Service Bulletin

2014 NC700X/XD Combination Meter Replacement PRODUCT UPDATE CAMPAIGN

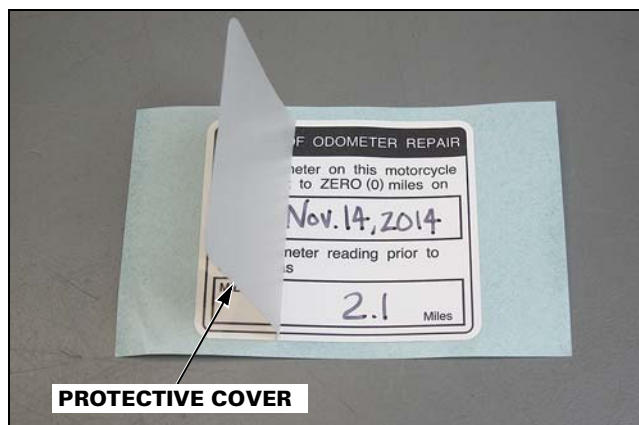
Before you begin the repair procedure, check if the update has been performed on the affected unit by looking for a punch mark on the frame as shown in the IDENTIFICATION section of this Service Bulletin.

When you have completed the update, place a punch mark on the right side of the frame, just below the drain hole as shown.

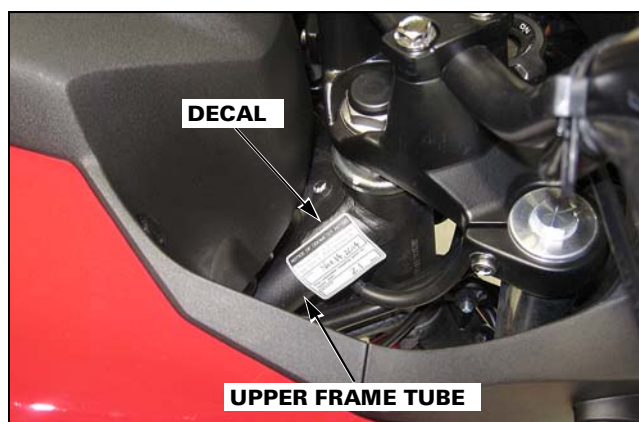
3. Peel off the blue adhesive backing from the decal and then apply the decal to the upper frame tube at the position shown.

NOTE: If the original odometer indicates mileage, by law the decal must be applied. The decal is a one-use type and will self destruct if you try to remove it after initial application. Be sure to clean the frame surface with isopropyl alcohol and then apply the decal correctly the first time.
